Subject: Conduit Support Walkdown Questions
Comanche Peak Steam Electric Station
Independent Assessment Program - Phase 4
Texas Utilities Generating Company
Job No. 84056

CONDUIT WALKDOWN QUESTIONS

Conduit Support Walkdown Checklist

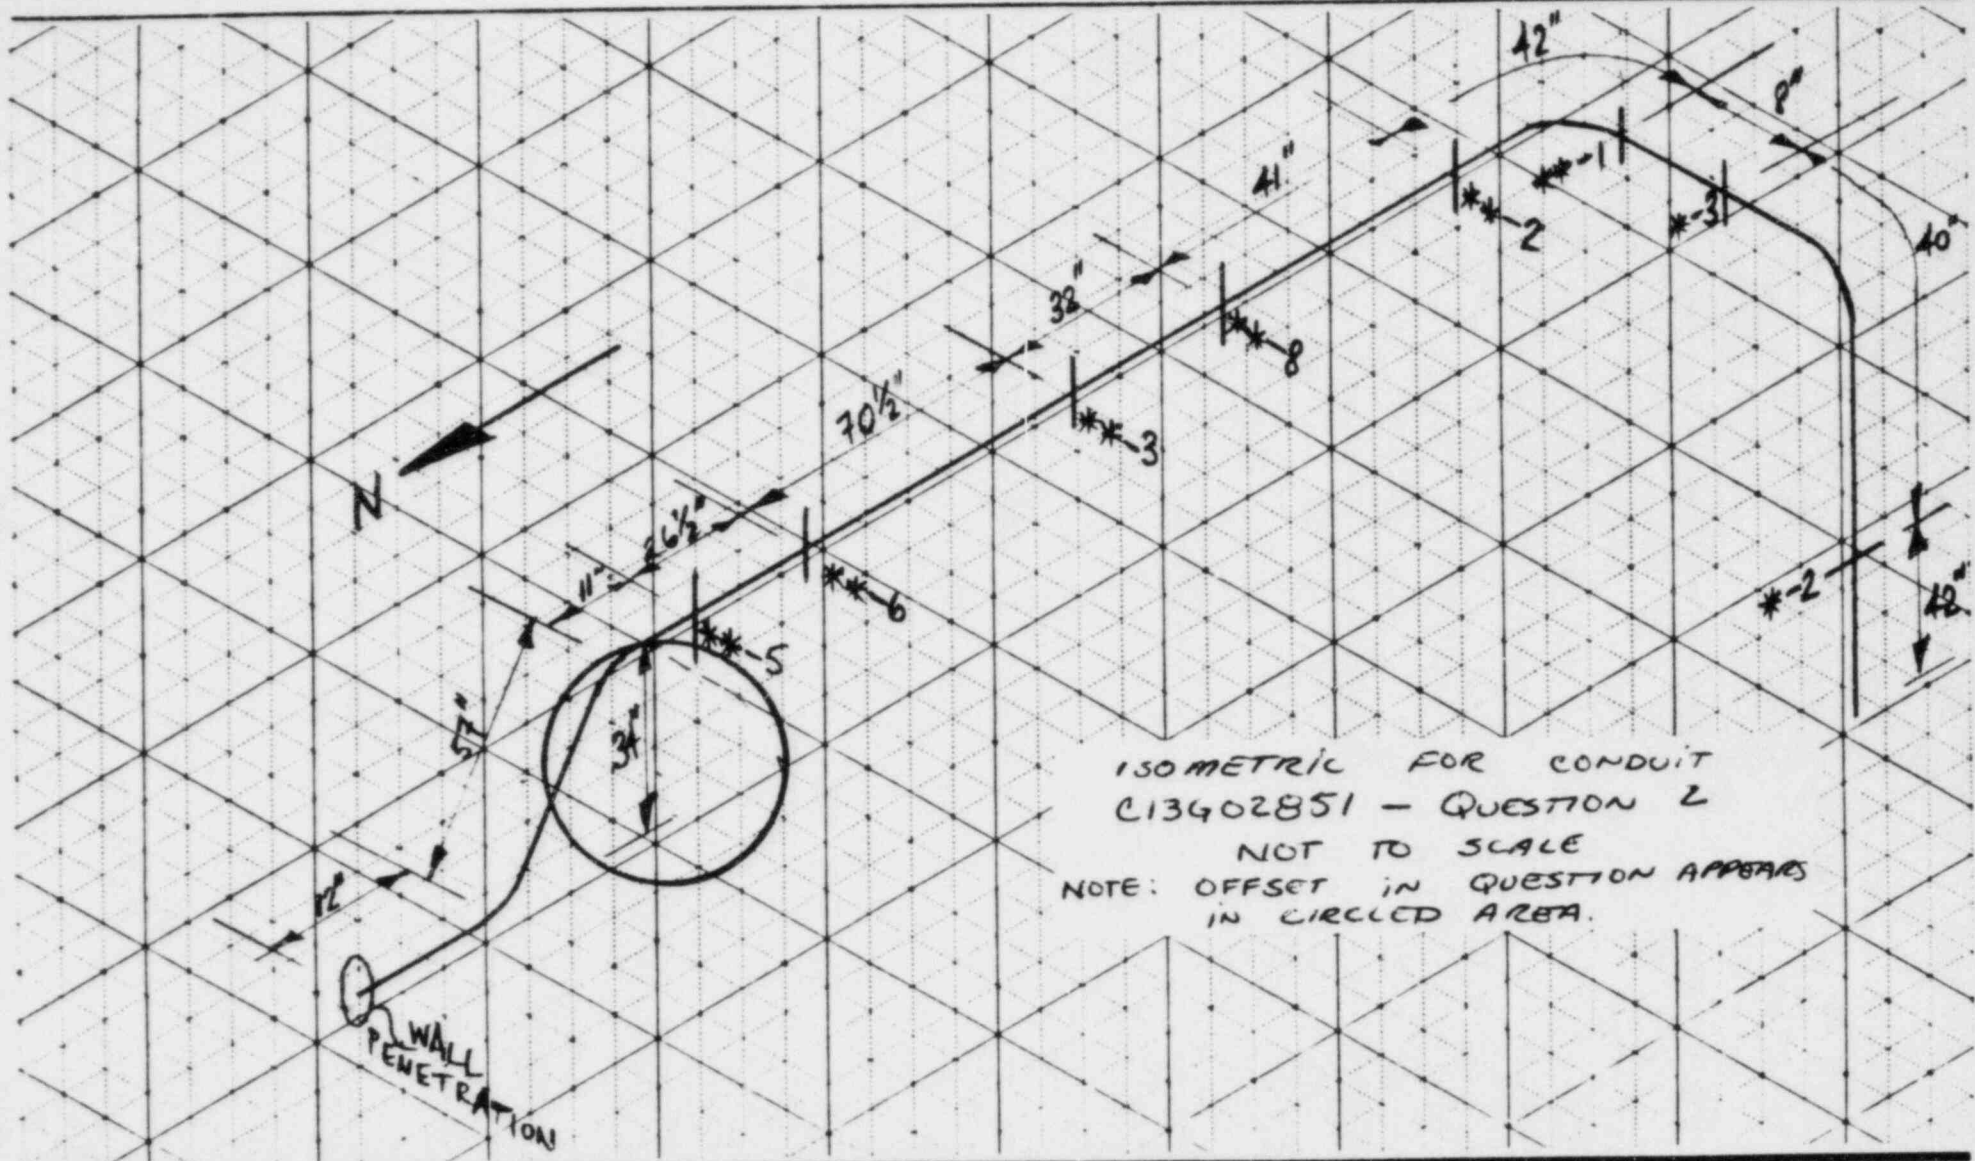
2. Conduit C12G02851 contains an S_3 offset of 2'-10". The allowable S_3 offset for a 1" diameter conduit per drawing 2323-S-0910, p. 6, sht 2, revision 8 is 2'-3". (See Cygna isometric sheet, attached).

Please provide Cygna with justification for allowing an offset dimension of $S_3 = 2'-10"$ for conduit C12G02851 which exceeds the allowable of $S_3 = 2'-3"$.

DEFORMED CONDUIT CLAMP
FOR CSD-5a TYPE
CONDUIT SUPPORT

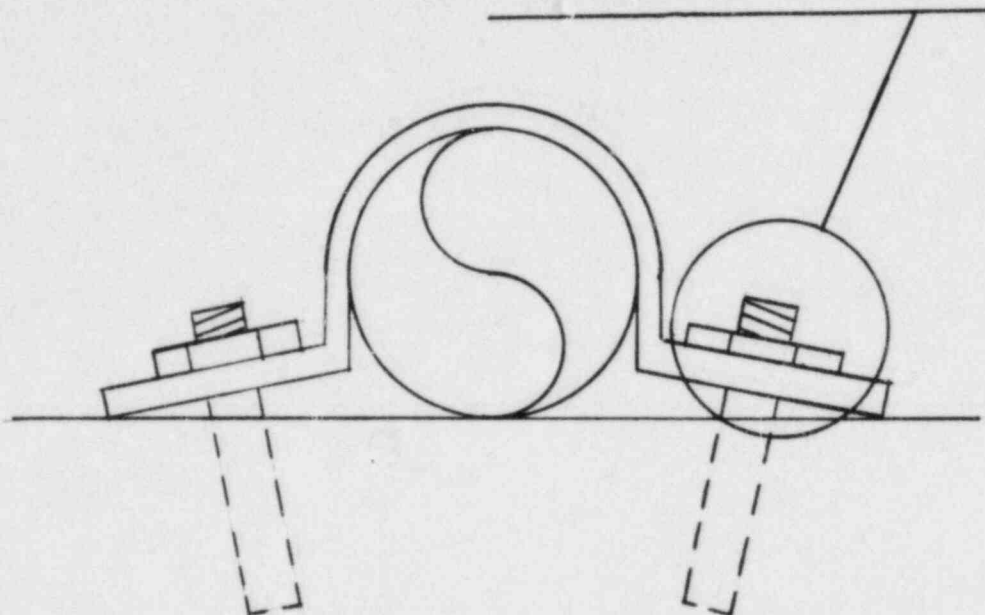
3. Conduit supports C12G02851-6 and C12002935-3 are type CA-5a supports. Cygna's walkdown noted that the conduit clamps were severely deformed in their installed position. As indicated by the attached sketch, even with the clamp deformation, expansion anchor nuts and washers were in full bearing against the clamp, indicating that the anchors were installed at angles to the perpendicular to the concrete surface.

Please provide Cygna with documentation which addresses the acceptability of deformed clamps as described above.

PLAN VIEW OF
SUPPORT CII Ø 04359-1
TYPE IN-CSM-154

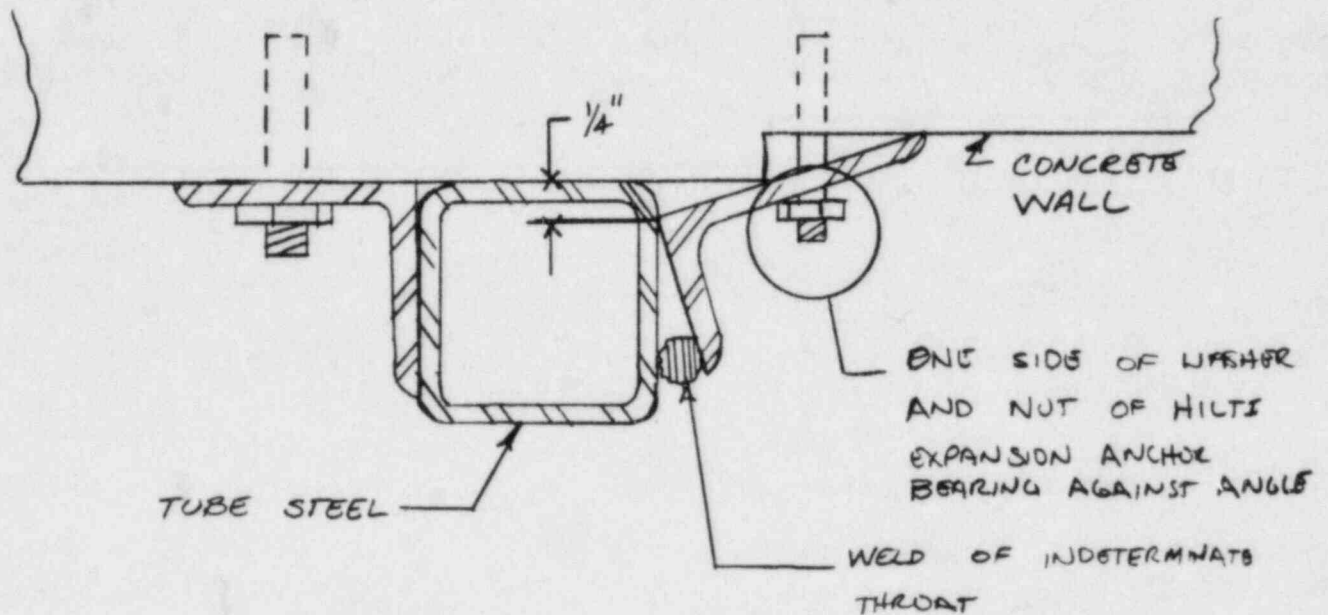
4. For support C11004359-1, type IN-CSM-15a, Cygna's walkdown noted the installed configuration appears as shown in the attached sketch. Due to an irregular concrete surface, the leg of the right angle is not flush against the tube steel section but is rotated such that the tip of the other leg is in bearing against the concrete.

The installed configuration impacts the functional capacity of the support in the following fashion:

- a. The bearing area required for proper load transfer at the support concrete interface may not exist which would result in concrete stresses greater than allowables.

- b. With the angle rotated as shown, only one side of the Hilti expansion anchor is in bearing against the angle. Such a configuration results in the introduction of bending stresses within the bolt which have not been considered in the design.
- c. Due to the rotation of the angles, it would not be possible to place the groove welds between the tube and the angle as shown on the support drawing.

Please provide Cygna with justification for QC acceptance of the base angle installation for support C11004359-1.
